Class 2 Permit Modification Request

Update Ventilation Language

**Waste Isolation Pilot Plant
Carlsbad, New Mexico**

WIPP Permit Number - NM4890139088-TSDF

Figure 5
Location of Worker Emplacing RH-TRU Mixed Waste

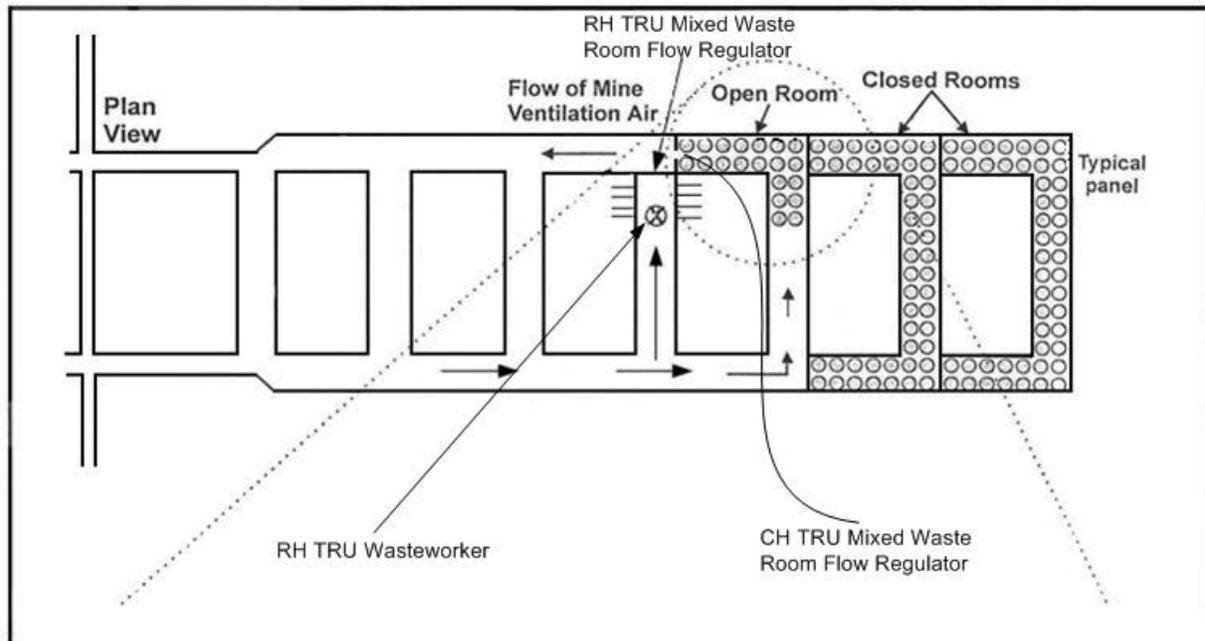
At the time the Permit was issued in 1999, RH TRU waste was prohibited and RH TRU waste emplacements were not included in the NMED’s analysis. Rooms that are being filled with RH TRU waste represent one additional scenario as shown in Figure 5. As can be seen in Figure 5, the worker is unaffected by normal operations or a roof fall in the adjacent CH TRU mixed waste room and by any roof fall scenario in the adjacent closed room by virtue of the fact that the ventilation flow through the active CH TRU mixed waste room bypasses the active RH TRU mixed waste room. Volatile Organic Compound emissions from RH TRU waste itself are negligible due to the low volume of RH TRU waste being emplaced, and emplacement of RH in boreholes with shield plugs. This is supported by the room-based measurements made at the exhaust of the active RH TRU mixed waste room shown in Figure 6. This figure shows the measurements in Room 7 exhaust for Panels 5 and 6. These are the only cases where the Permittees measure emissions that are due to RH TRU mixed waste only. The values (through May 17, 2011) range from zero to 4.5 parts per billion (volume). The highest value is seven orders of magnitude below any room-based action level and is an indication that RH TRU mixed waste is contributing very little to overall concentration of carbon tetrachloride in the panels.

Figure 7
Current and Proposed Routes

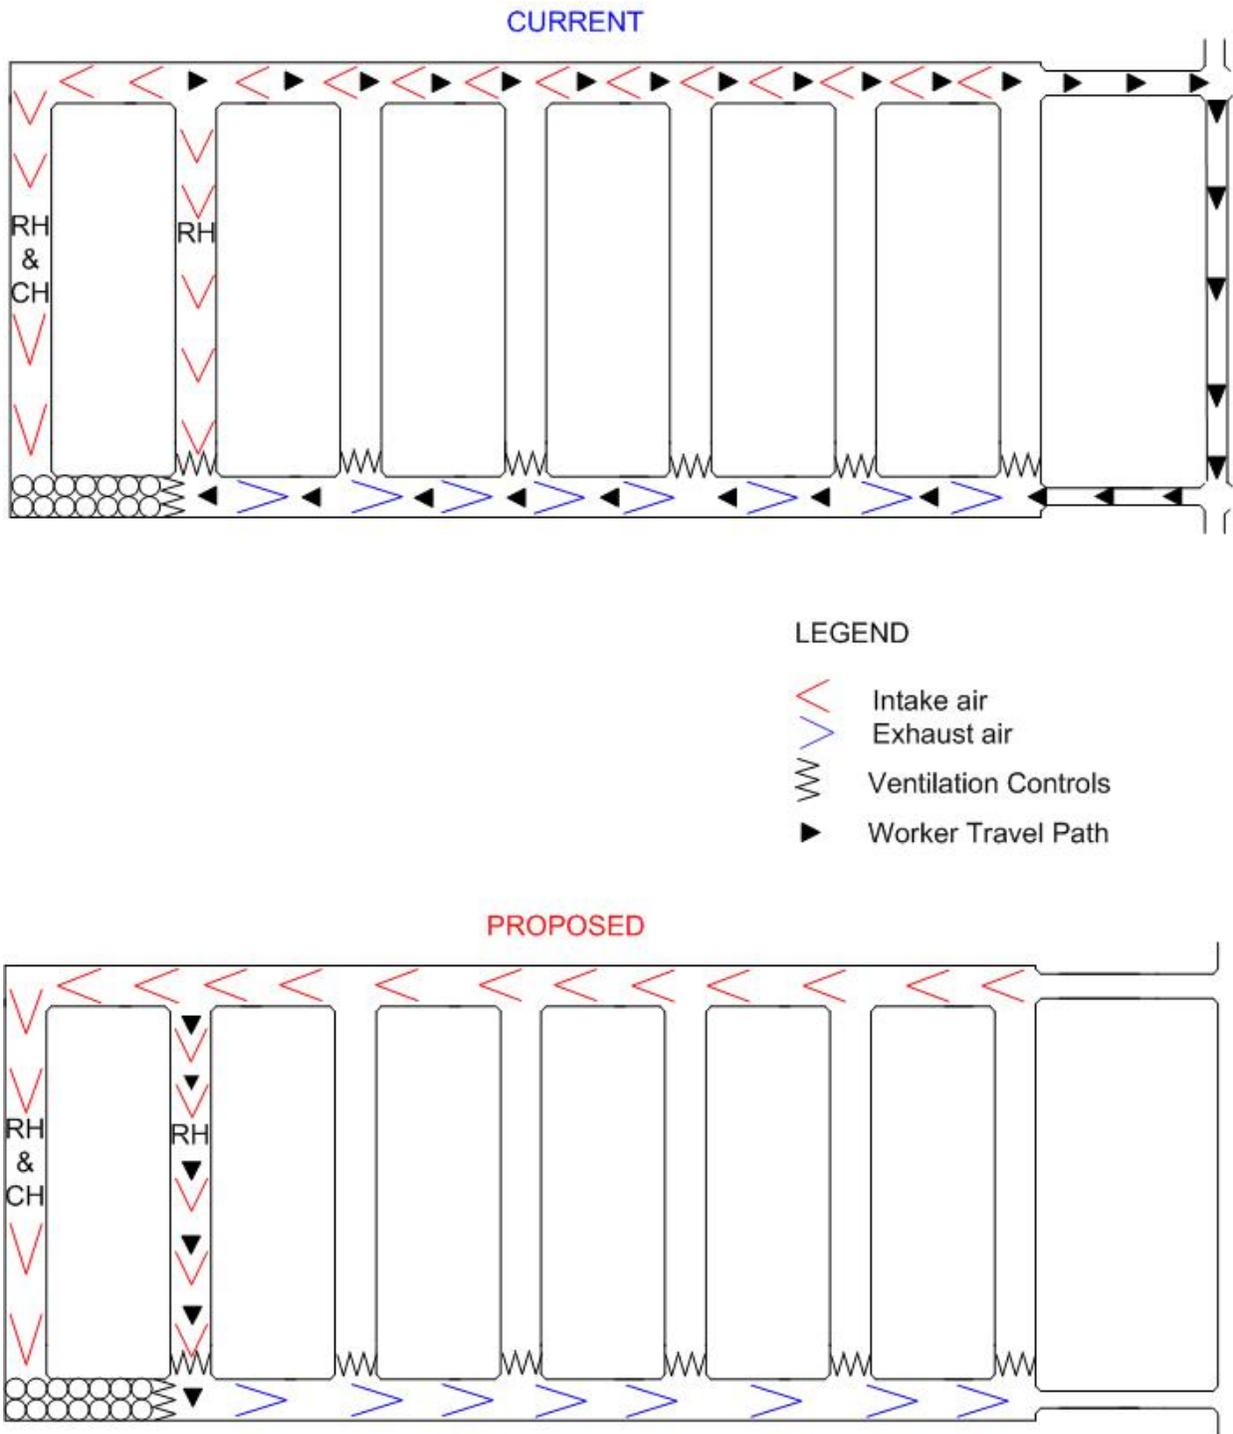
Figure 7 shows the current and proposed worker pathways to adjust the ventilation regulators. Clearly, the pathway allowed by this proposed modification is significantly shorter and thereby reduces the time that a worker must be downstream of the emplaced waste.
